**Subject:** Response to U.S. Nuclear Regulatory Commission Request for Additional Information Regarding Inservice Inspection Relief Requests RI-21, Revision 2, and RI-36  
Cooper Nuclear Station, Docket No. 50-298, DPR-46

**Response to NRC Request for Additional Information Regarding  
Inservice Inspection Relief Requests RI-21, Revision 2, and RI-36**

**Nebraska Public Power District  
Cooper Nuclear Station**

Sketch Of Limitation(s):

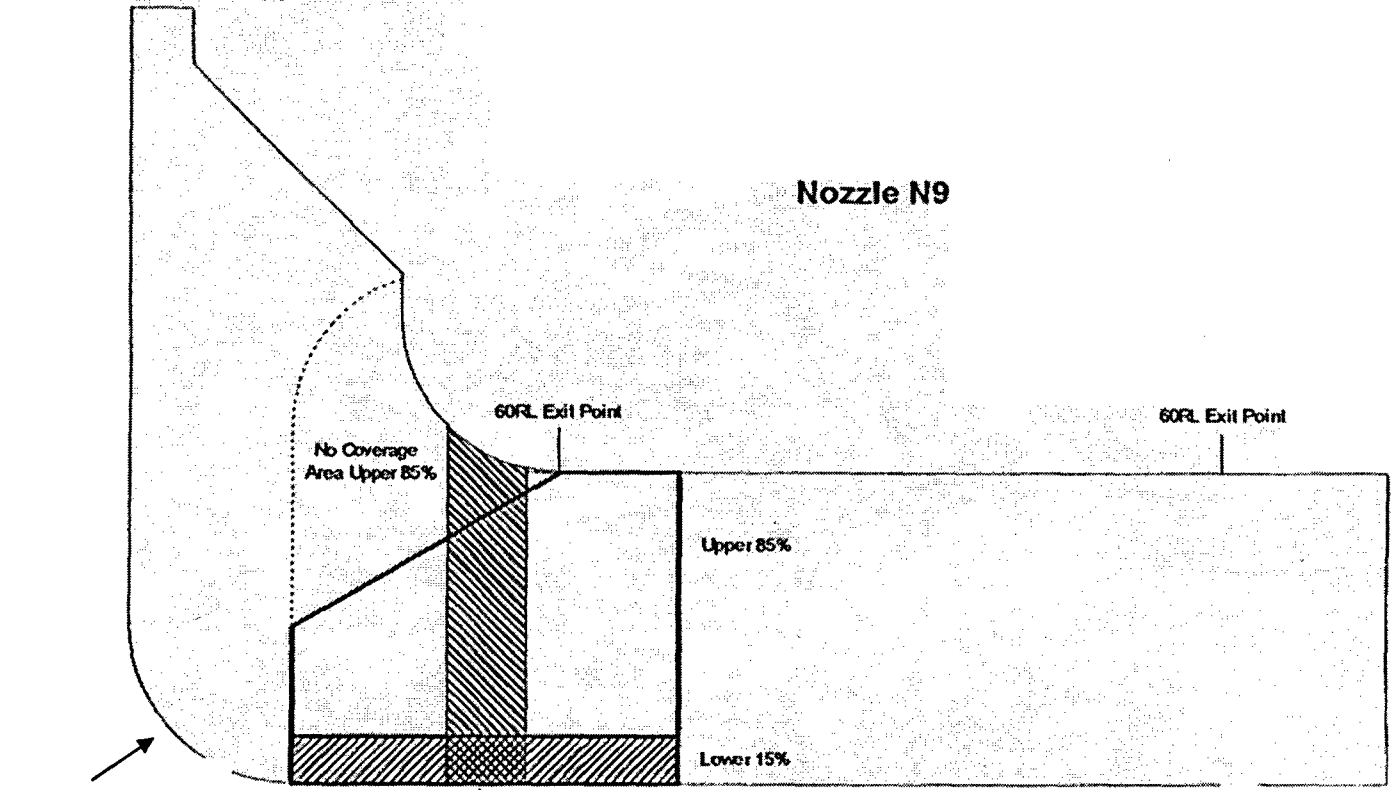
*The licensee stated that the total volumetric examination coverage of nozzle NVE-BD-N9 was 40 percent. The figure in the attachment to the September 28, 2005, letter does not provide sufficient information regarding how the 40 percent coverage was achieved. Please demonstrate the 40 percent coverage by calculations and diagrams.*

*The submittal stated that the inner radius examination of nozzle NVE-BD-N9 in the third interval achieved 100 percent of the required examination volume. It also stated that the inner 15 percent of the nozzle received 100 percent coverage. Discuss why the volumetric examination can achieve 100 percent coverage in the inner radius region, but only 40 percent coverage was achieved.*

The ultrasonic examination volume includes the outer 85 percent thickness and the inner 15 percent thickness as measured from the inside diameter surface. The 60 degree RL scans were used to examine the entire weld volume with the exception of the lower 15 percent in the circumferential direction. The EPRI Model parameters were used to inspect the lower 15 percent of the examination volume using the required shear wave scans.

The 60 degree RL/Zone -1 and the 60 degree RL/Zone -2 scans, along with the combined model scans were used to calculate the total examination coverage and limited/no scan area not covered by these techniques. The examination limitations are shown in square inches in order to simplify calculations.

The figure below shows the examination volume limitations to the applicable examination zones as required per ASME Section XI, Figure IWB-2500-7(a).

**NVIR-BD-N9**  
**(RPV Nozzle to Shell – Nozzle**  
**Inner Radius Section)**  
**100% coverage achieved.**  
**Previous exam achieved 70%.**

**NVE-BD-N9**  
**RPV Nozzle to Shell Weld Lower 15% (i.e., inner**  
**15%) received 100% volume coverage.**

The 40 percent coverage stated in the relief request only applies to the nozzle-to-shell weld zone NVE-BD-N9. Within the required examination volume associated with NVE-BD-N9, that zone or volume is divided into the lower 15 percent region and upper 85 percent region of the nozzle-to-shell weld examination volume. The relief request stated that 100 percent coverage was achieved for the lower 15 percent region, which is the region of most concern for flaw initiation. The upper (outer) 85 percent region is less of a concern.

The figure on Page 3 of this attachment shows the exam volume associated with NVE-BD-N9 and NVIR-BD-N9. The inner radius zone (NVIR-BD-N9) is a different exam volume than the inner 15 percent region shown as the cross-hatched area in the figure. The area to the left of the cross-hatched area is the inner radius zone that is examined under a different technique and reported on a different data sheet. With our most recent examination, we achieved 100 percent of the inner radius zone compared to 70 percent in Interval 2 (1995). Since we achieved 100 percent code-required volume for the inner radius zone, we revised the table in the relief request to remove the inner radius zone coverage of 70 percent that was previously approved by the NRC in Revision 1 of the relief request.

Sketch Of Limitation(s):

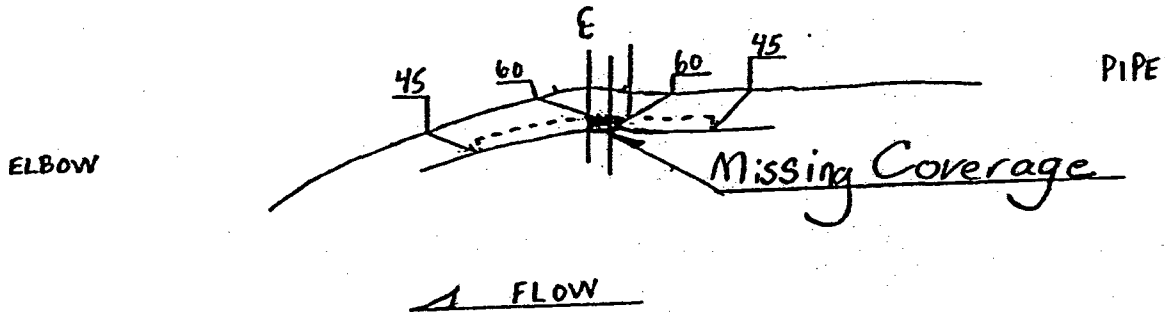
*Provide a drawing of the subject welds RVD-BJ-17 and RVD-BJ-18, including the volume that were volumetrically examined, angle and trace of transmitting and receiving signals, and examination interferences.*

The drawings of the welds are provided on the enclosed Ultrasonic Examination Scan Limitation Sheets (page 5 of 5 for each data set) for Welds RVD-BJ-17 and RVD-BJ-18.

The limitation was due to the "as welded" crown. (See the enclosed Ultrasonic Examination Scan Limitation Sheets, page 5 of 5 for each data set.) Conditioning the crown may have achieved more examination volume coverage; however, the inadvertent removal of weld metal below code minimum on a thin material may have occurred on one or both of the segments and, therefore, was not performed. There were no other interferences identified.

84.21% code volume achieved.

Total coverage missing .015"<sup>2</sup>

Limited exam due to weld crown height.
